Model: SPDF DF3080	Date: 26-Jun-13	No.: RD683001c
--------------------	-----------------	----------------

Subject: Firmware Release Note: SPDF DF3080		Prepared by: T. Toriumi	
From: 1st Tech Service Sect., MFP/Printer Tech Service Dept.			
Classification:	<input type="checkbox"/> Troubleshooting <input type="checkbox"/> Mechanical <input type="checkbox"/> Paper path <input type="checkbox"/> Product Safety	<input type="checkbox"/> Part information <input type="checkbox"/> Electrical <input type="checkbox"/> Transmit/receive <input checked="" type="checkbox"/> Other (Firmware)	<input type="checkbox"/> Action required <input type="checkbox"/> Service manual revision <input type="checkbox"/> Retrofit information <input checked="" type="checkbox"/> Tier 2

Model: MET-C1b		Date: 10-Apr-15	No.: RD147138
Subject: Thread and tear the feed belt		Prepared by: N. Yoshida	
From: 1st Tech Service Sect., MFP/P Tech Service Dept.			
Classification:	<input checked="" type="checkbox"/> Troubleshooting <input type="checkbox"/> Mechanical <input type="checkbox"/> Paper path <input type="checkbox"/> Product Safety	<input type="checkbox"/> Part information <input type="checkbox"/> Electrical <input typ

Location:

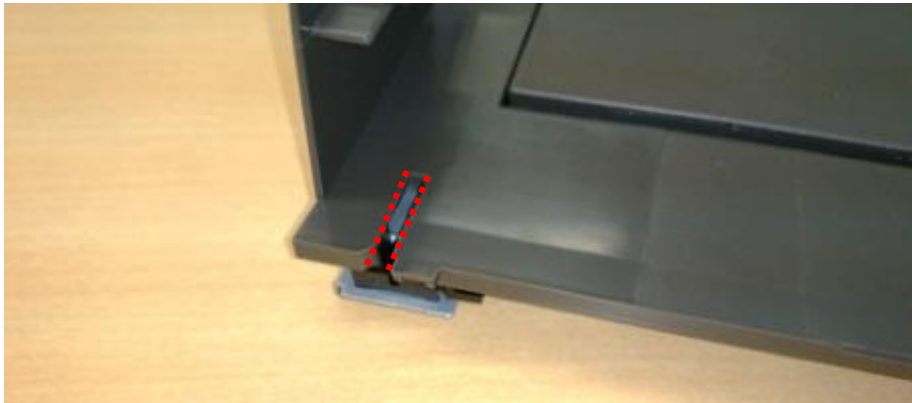
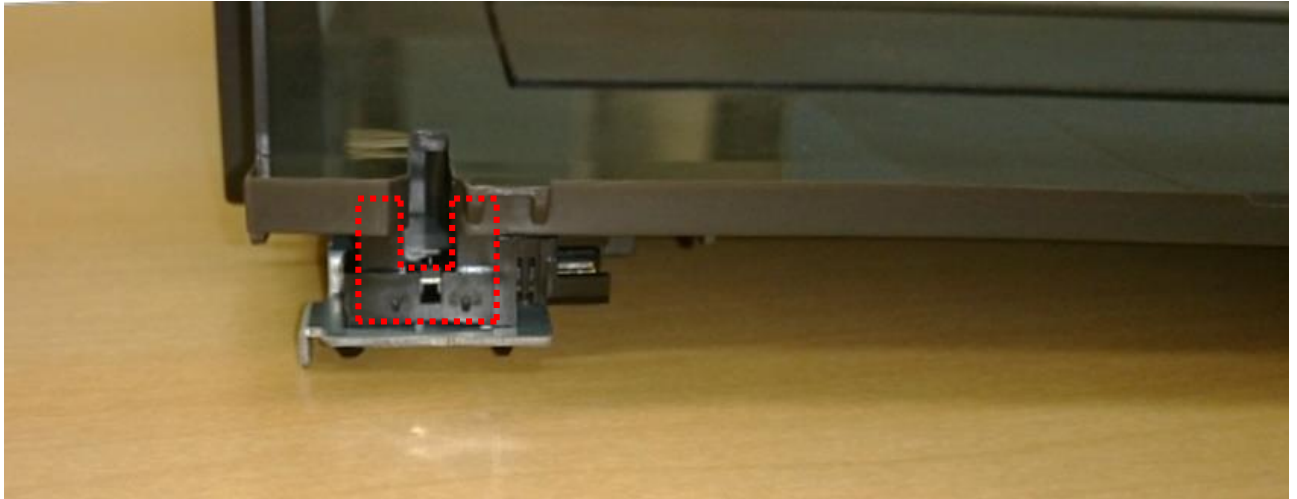
The shape of the BASE:ORIGINAL TABLE and ORIGINAL SENSOR was changed to avoid possible jams on the last page of an original.

BASE:ORIGINAL TABLE**Old****New**

ORIGINAL SENSOR**Old****New**

Table below shows the interchangeability. Jam may occur in the combinations indicated NG. Be sure to use new sensor (p/n: AW020190) when replacing the ORIGINAL TABLE.
